Contract #: 04-0120F4Cty: SF/ALA Rte: 80 PM: 13.2/13.9File #: 69.25B**QUALITY ASSURANCE -- NON-CONFORMANCE REPORT****Location:** Changxing Island, Shanghai, P.R. China**Report No:** NCR-000730**Prime Contractor:** American Bridge/Fluor Enterprises, a JV**Date:** 05-May-2010**Submitting Contractor:** Zhenhua Port Machinery Company, Ltd (ZPMC), Changxing Island**NCR #:** ZPMC-0693**Type of problem:**

Reference Description: Missed UT indication by QC on Lift 13W Floorbeam Weld**Description of Non-Conformance:**

Dear: Mr. Charles Kanapicki
Job Name: SAS Superstructure

Subject: NCR No. ZPMC-0693

Reference Description: Missed UT indication by QC on Lift 13W Floorbeam Weld

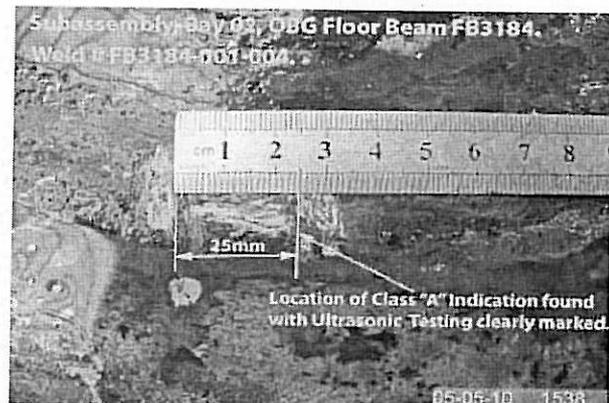
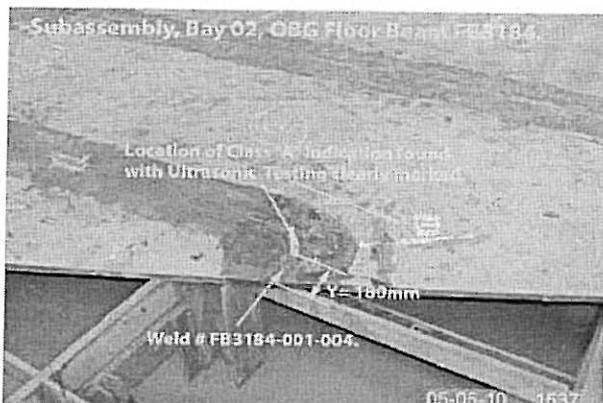
During the Quality Assurance (QA) Ultrasonic Testing (UT) verification of welds located on OBG Floor Beam (FB), this QA Inspector discovered the following issue:

- One (1) longitudinal "Class A" indication measuring approximately 25mm in length.
- The D rating was +6dB at a depth of 26.15mm and the thickness of the steel material is 35mm.
- The weld is identified as: FB3184-001-004, located at Panel Point 119-1500 (Lift 13W)
- The weld is a Complete Joint Penetration (CJP) butt weld joining FB plate X4397A to FB plate X7501A.
- The "Y" location of the indication is approximately 180mm from nearest end of the weld and is clearly marked on or near the weld.
- This material is designated as Seismic Critical Performance Members (SPCM).
- This FB member is located in Bay 02.

The Notice of Witness Inspection Number (NWIT) is 005665. The indication is located inside the area that has been previously tested and accepted by ZPMC Quality Control (QC) personnel. As per the contract documents, ZPMC's QC personnel are required to perform one hundred (100%) percent UT inspection of this weld.
